#### **Addendum Number Two**

To The Drawings and Specifications for Household Hazardous Waste Facility Bid # 24-0011, Sedgwick County, Kansas

You are hereby instructed to include in your bids the following changes and/or corrections to the Drawings and Specifications for the **Household Hazardous Waste Facility – 801 Stillwell, Wichita, Kansas.**

Issued: Friday, March 1, 2024

# DEMO PLAN BASEMENT

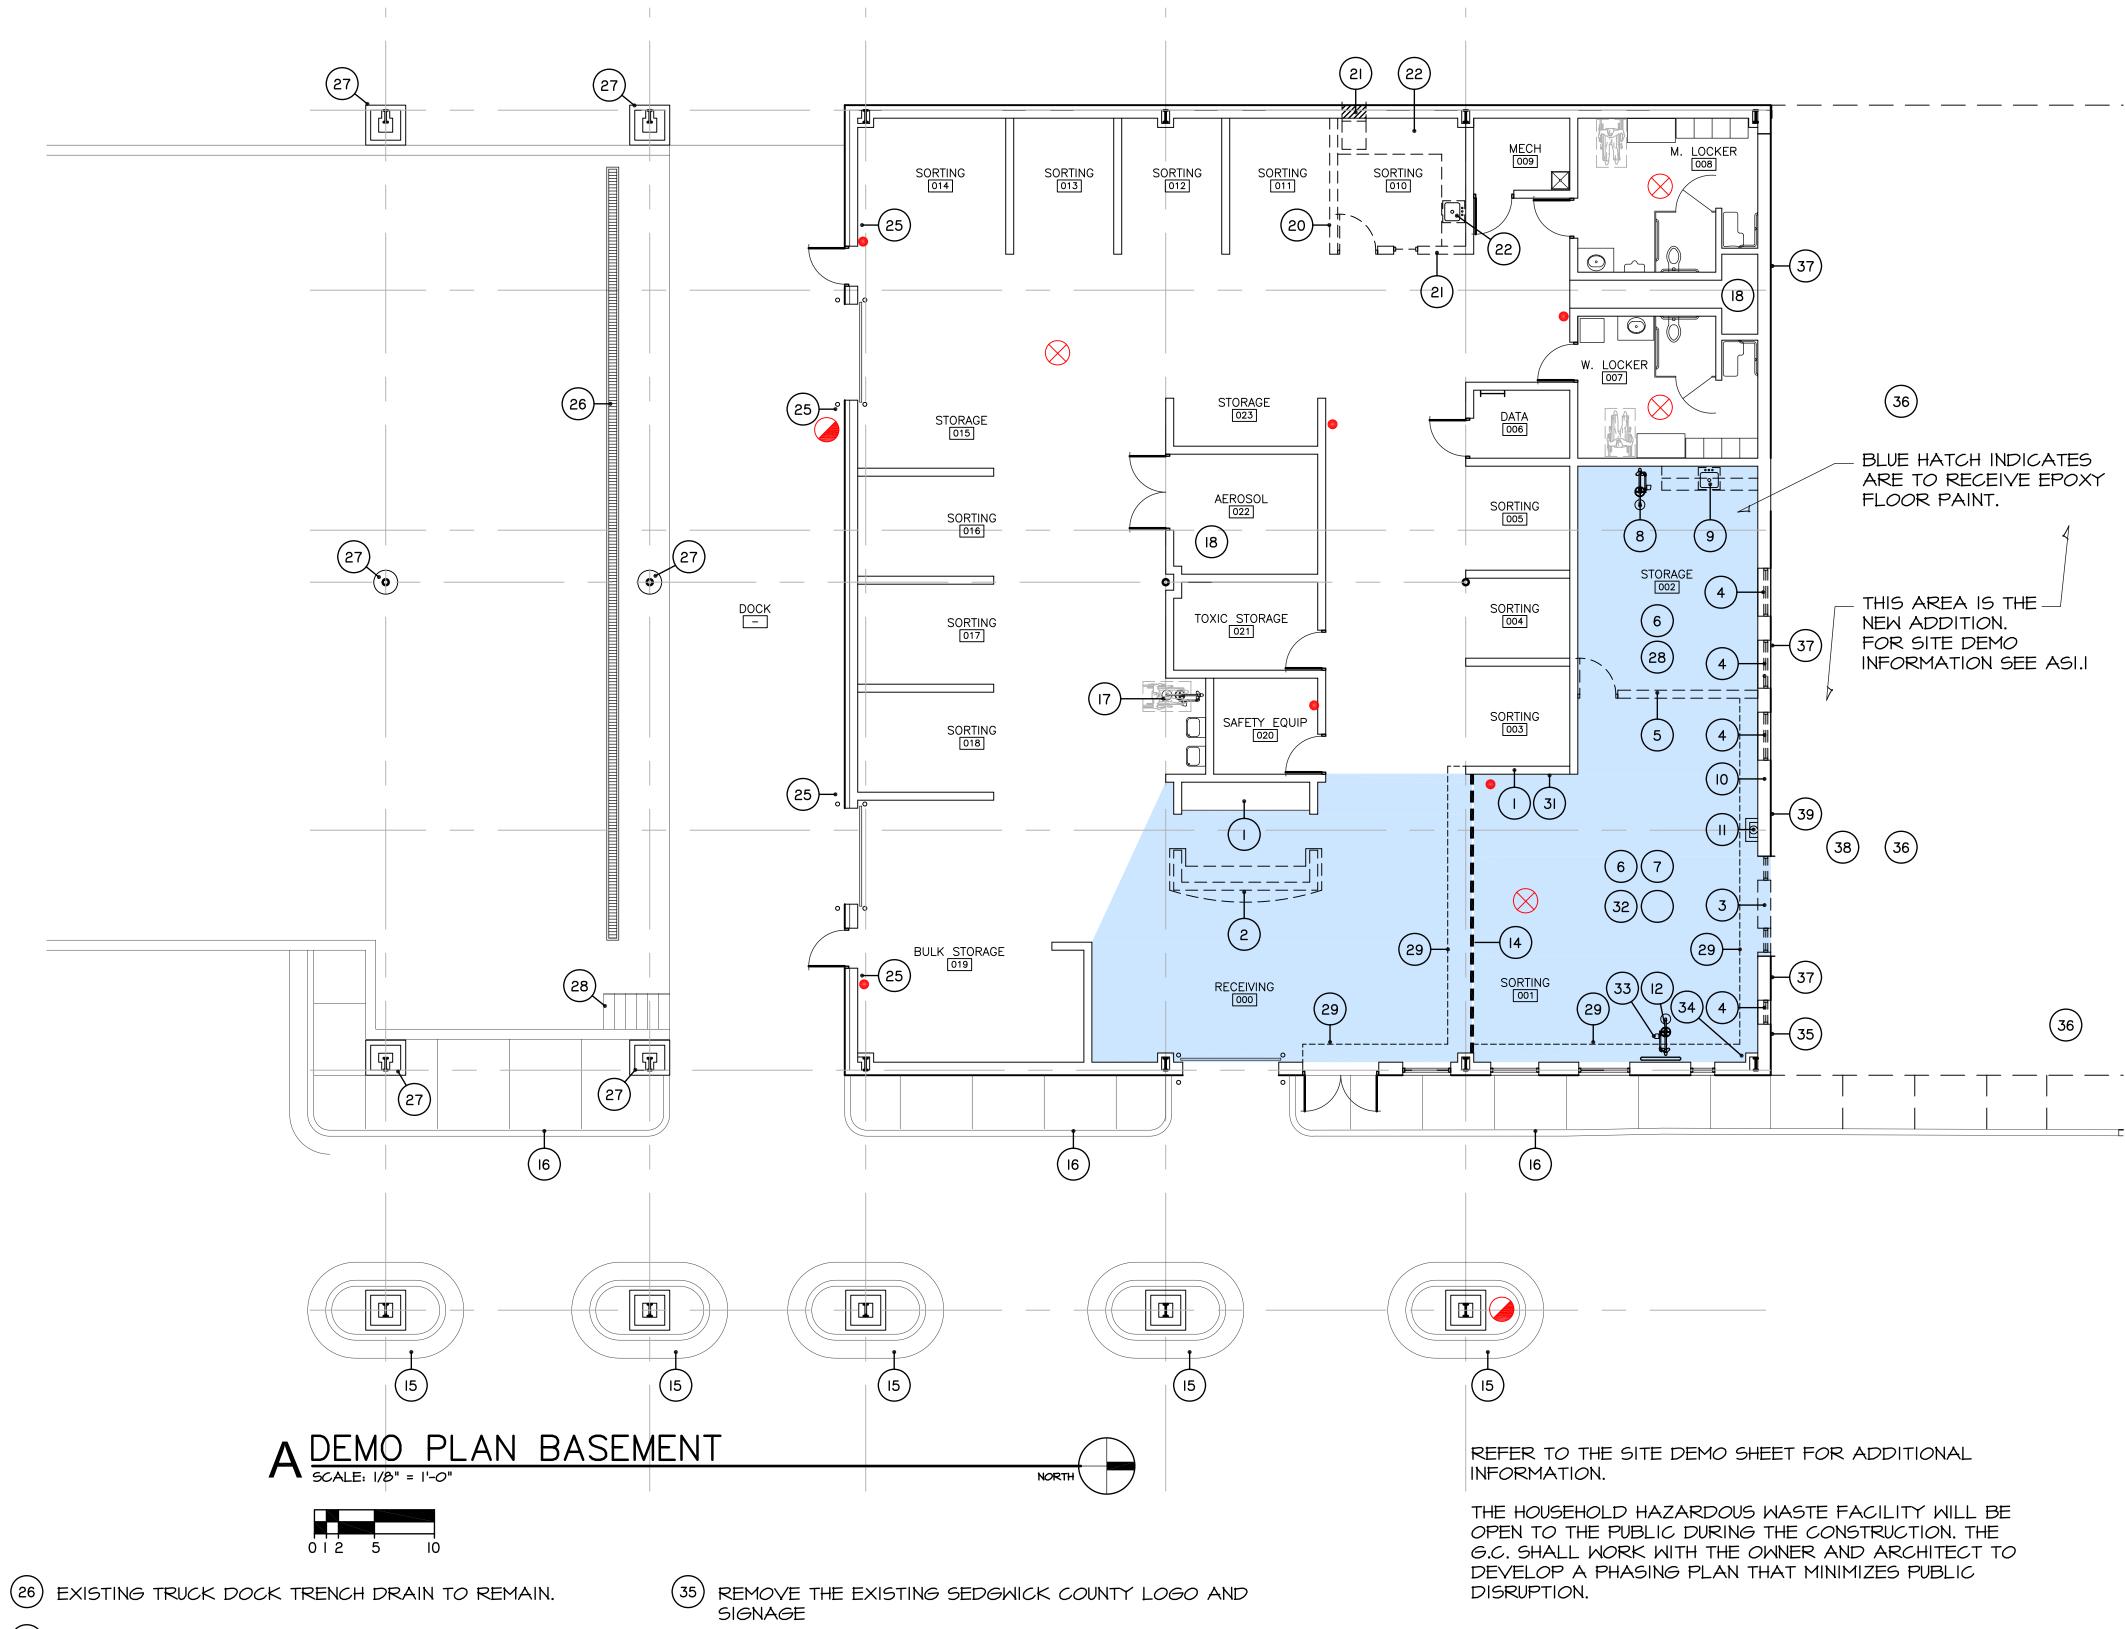
- 1.3 Demolition Sheet D1.1 is being issued with this addendum.
- 1.4 VT Architectural Wood Doors are approved for this project.
- 1.5 The new addition is where the concrete polishing will take place.
- 1.6 The finish material legend for F3 Polished Concrete on A8.1 says Class B Salt and Pepper to Class C coarse aggregate. Addendum 1, note 3.19 (b), references the desired level of aggregate to be Class B salt and pepper. We understand the amount of aggregate exposed during this process will vary. This is our way of allowing a variation. The finish shall be reviewed with the architect as the process is underway.
- 1.7 On drawing A8.1 Finish note #2

1.8 The Demo Sheet, D1.1, added by this addendum, helps define the limits of the floor work in the existing building.
